# Convertible Top

## Electrical Revision Document No 72261

**Model:** XK

**Pages Affected** Fig. 15.2 Convertible Top

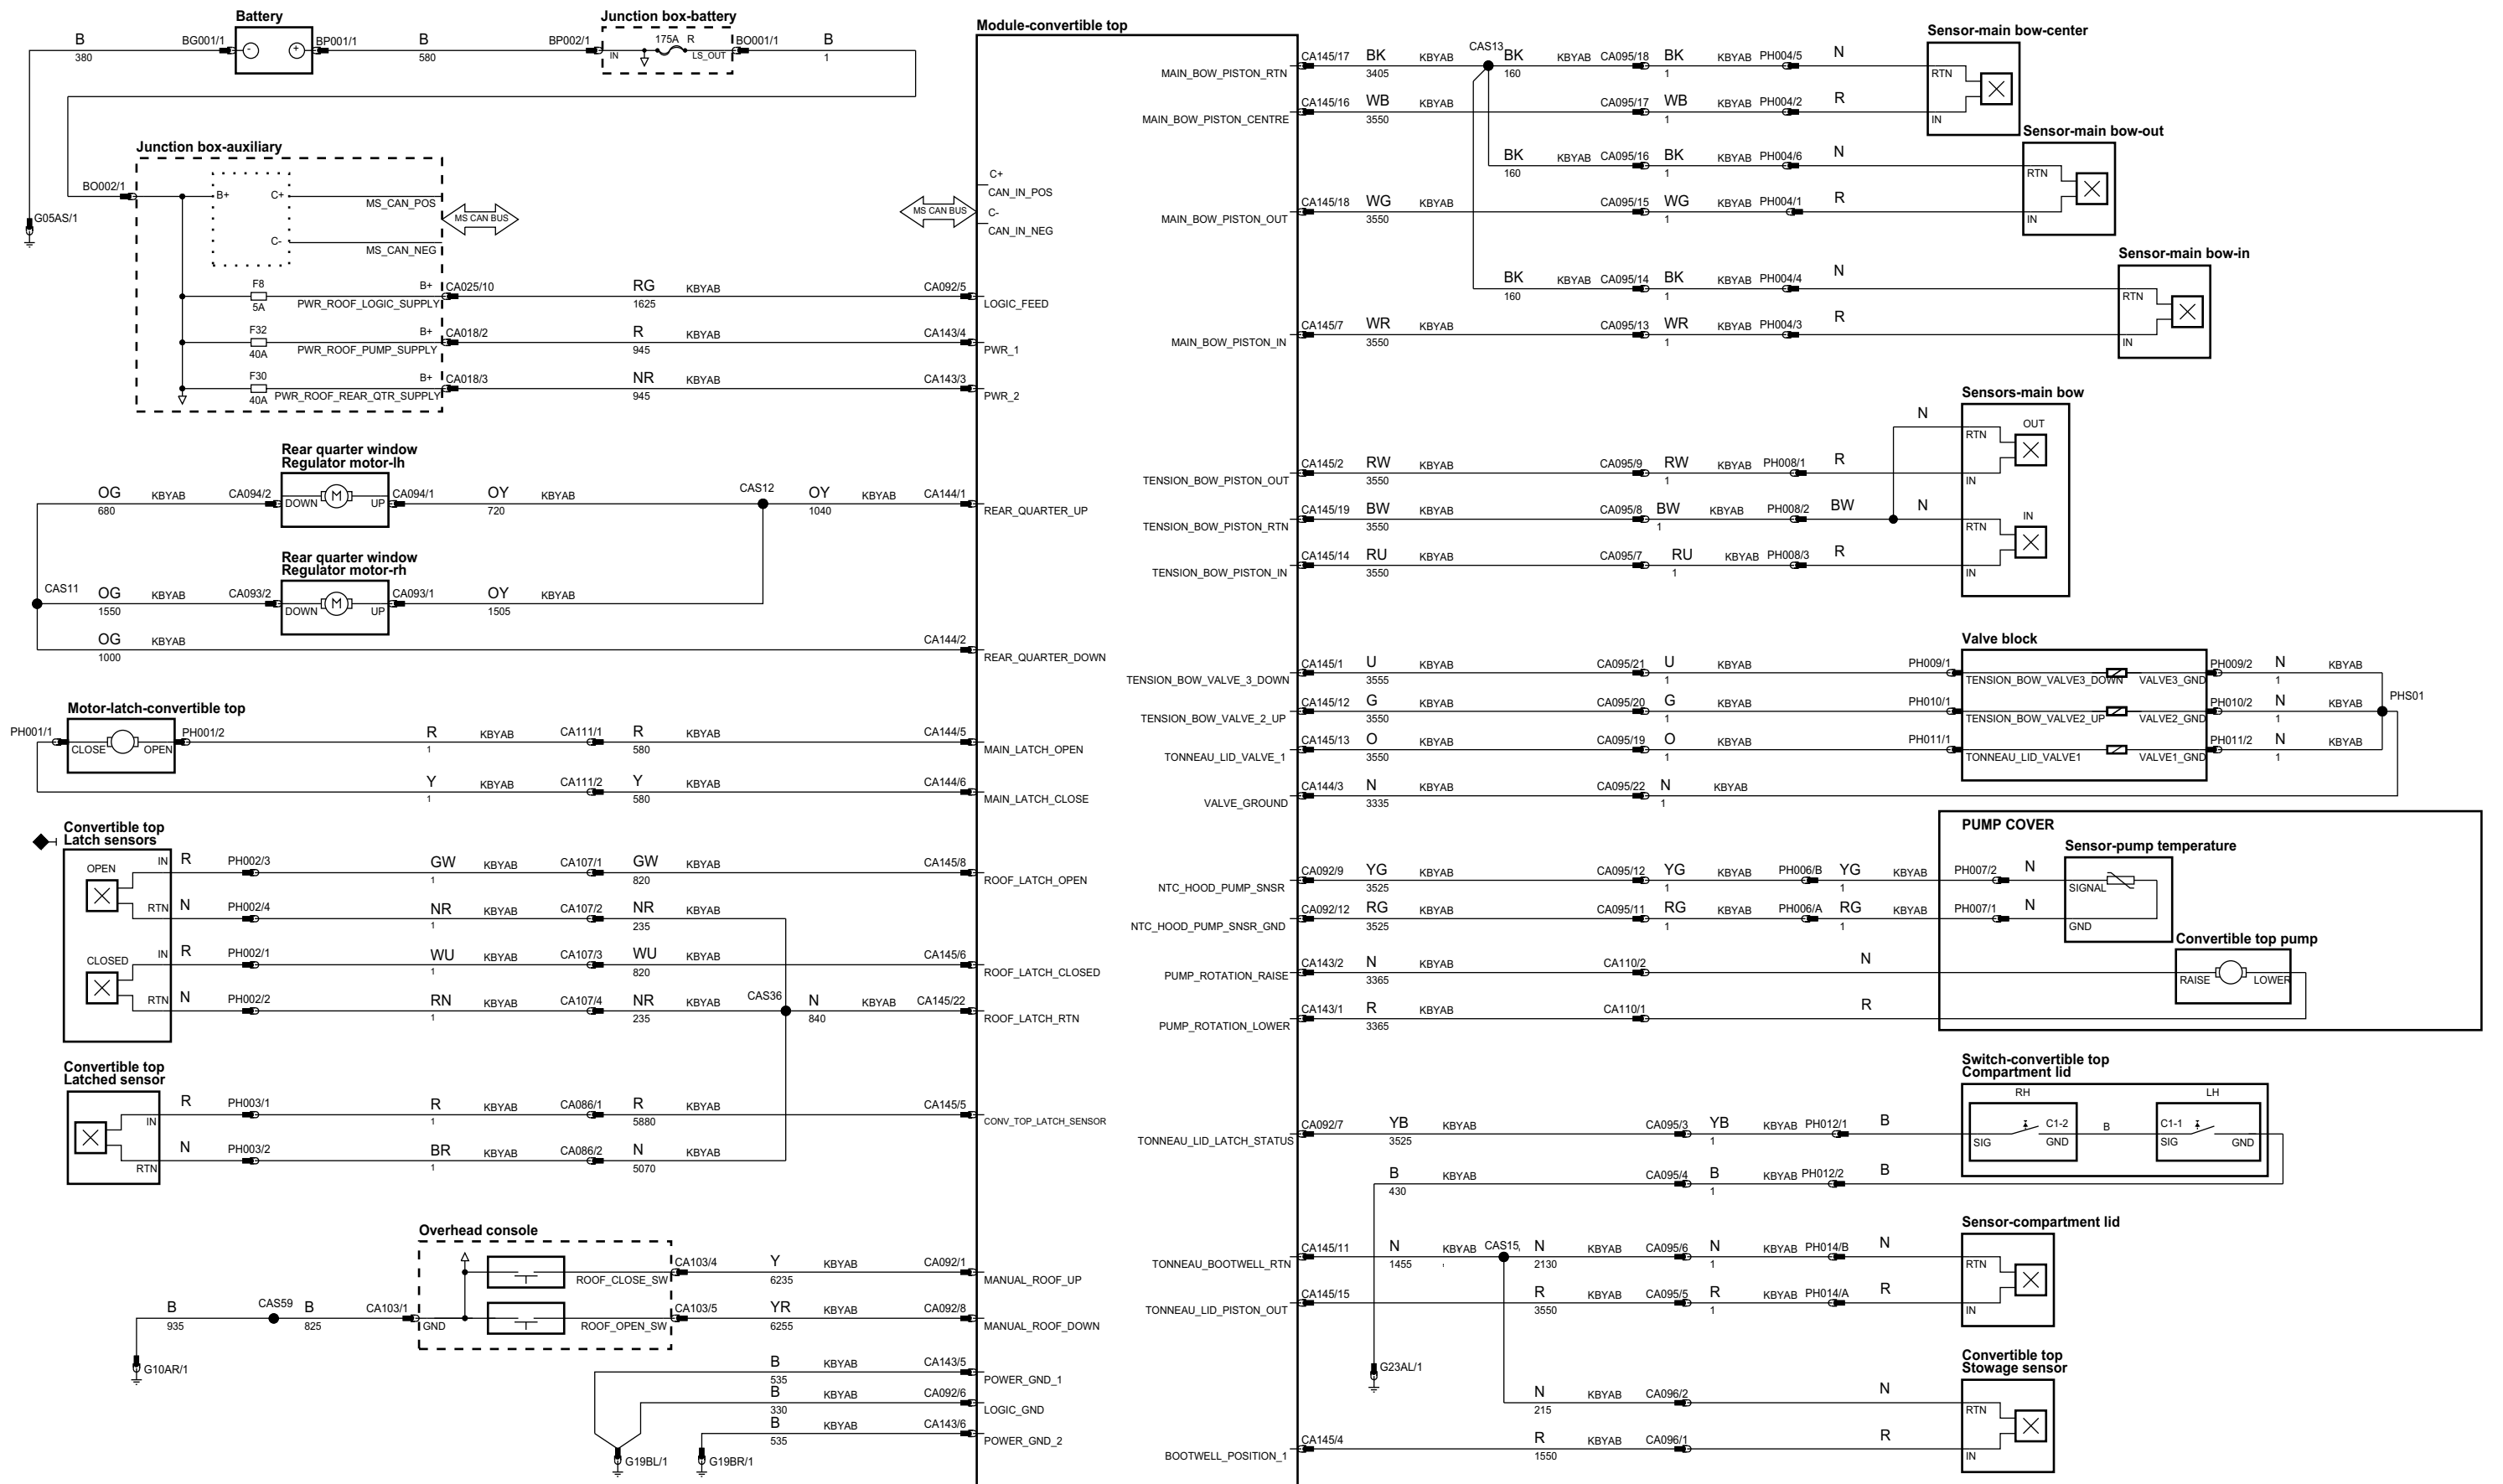
Fig. 15.2 of the original document indicated PH004 and PH005 were 3-way connectors.

The replacement Fig. 15.2 indicates PH004 is a 6-way connector and PH005 has been deleted.

Replace Fig. 15.2 with page 2 of this document.
